PRODUCT CHANGE NOTIFICATION

Bourns® SRP4018FA, SRP4020FA, SRP4030FA, SRP4020CA and SRP4030CA Series Shielded Power Inductors

Change in T-core Design

IC25006

Existing T-core

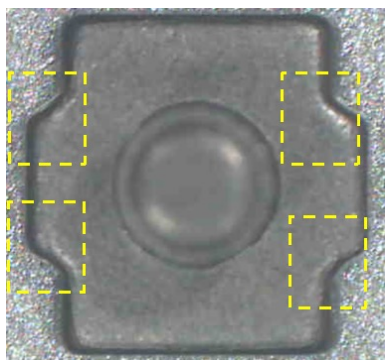
Riverside, California – February 18, 2025 – As part of our continuous improvement efforts, effective October 27, 2025, Bourns will change the T-core design for the [SRP4018FA](#), [SRP4020FA](#), [SRP4030FA](#), SRP4020CA and SRP4030CA Series Shielded Power Inductors. The copper wire joint of the T-core will have a slightly more right-angled shape to enhance structural stability. A list of affected part numbers is included below.
